Re: ODOARDI – Vacant Lot
22 Nethermont Ave. – New House Construction
Tax ID: Section 122.16 – Block 4 – Lot 7

This letter accompanies a response to comments and revisions to plans, in response to the comments received from the Planning Board Staff and Town Consulting Engineer.

G.E.S Revisions/Written Response to Comments addressing the Planning Board Staff Report, dated January 24, 2020, and Revisions/Written Response to Comments Received from Kellard Sessions (Town Consulting Engineer), dated January 24, 2020.

SOLID WHITE VINYL FENCE DETAIL

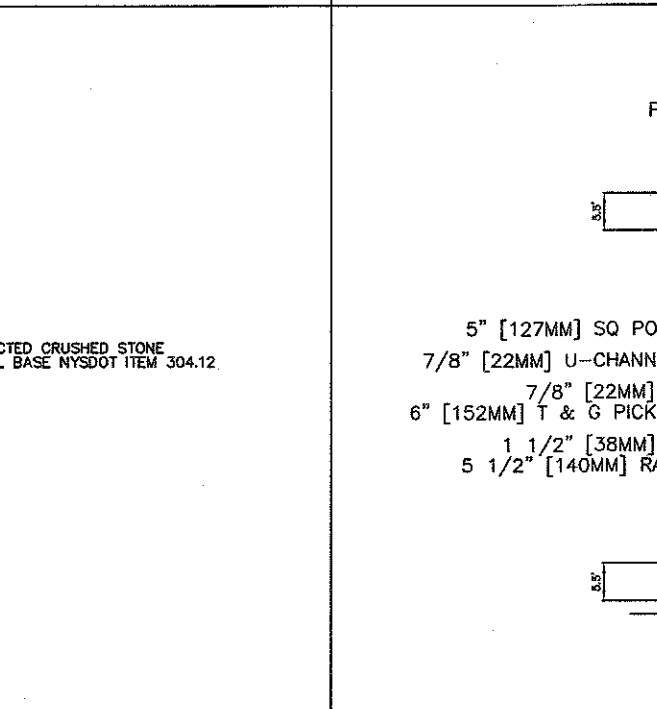
12. The site plan depicts the installation of a fence along the northern property line. A fence detail should be submitted for review.

- Detail of Fence has been added to SWEC Detail Sheet.

WATER MAIN CONNECTION DETAIL

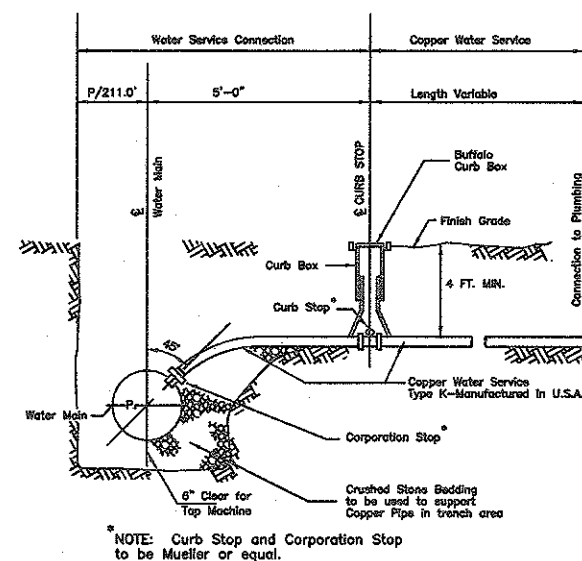
- Max curb cut noted at driveway exit.
18. The plan indicates a new one (1) inch water service that will be connected to an existing water main in Nethermont Avenue. A detail shall be provided for the new water line connection to the existing main. The Trench Restoration Detail shall be revised to comply with North Castle Highway Department Standards.

- Water main connection detail has been added to the utility plan.
19. Erosion control measures shall be illustrated on the proposed grading plan, including, but not limited to, silt fence, inlet protection, construction entrance and tree protection. The limit of disturbance shall be revised to illustrate and quantify all areas of disturbance on and off site.

22 NETHERMONT
PRE DEVELOPED AREAS USED IN
CALCULATIONS

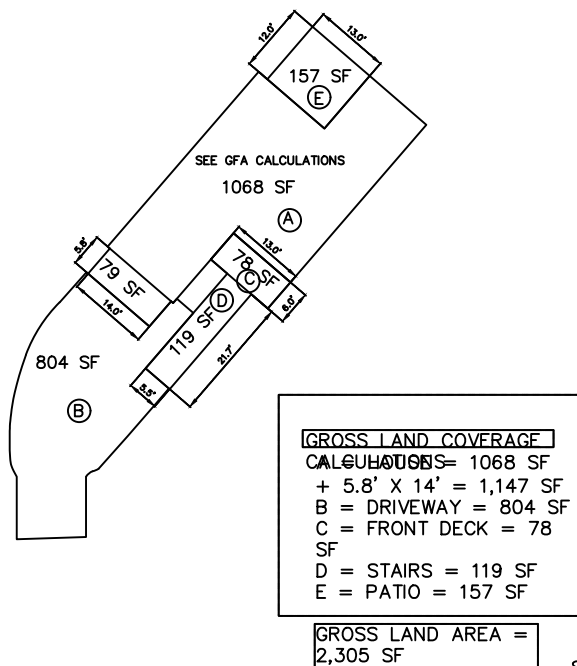
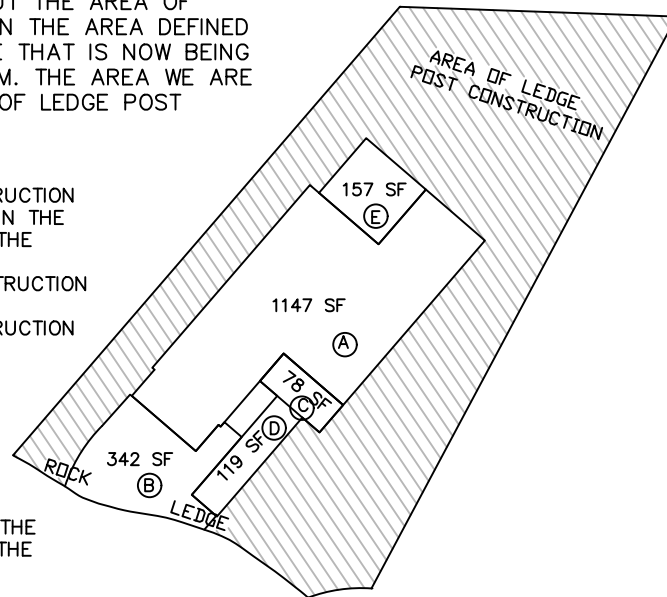
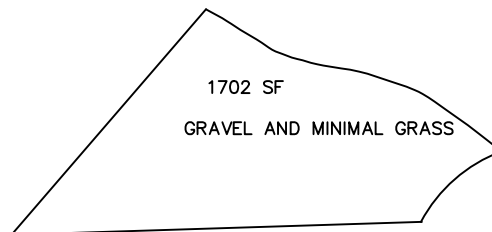
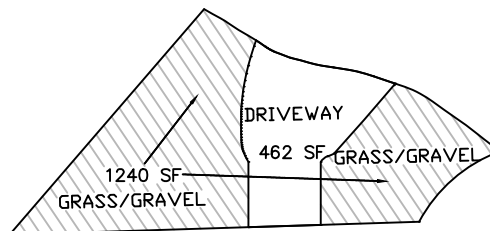
12. Provide stormwater mitigation and design calculations for the runoff generated by the net increase in impervious surfaces for the 100-year, 24-hour design storm event. All invert elevations of the stormwater detention system and outlet structures shall be coordinated between the plan, details and the calculations.

- Drainage areas associated with HydroCAD calculations has been attached to this submittal showing the areas used for pre and post calculations.
14. The proposed stormwater mitigation practice is located less than one (1) foot from the front property line. All stormwater practices shall be located a minimum of ten (10) feet from all property lines. The plans shall be revised accordingly.
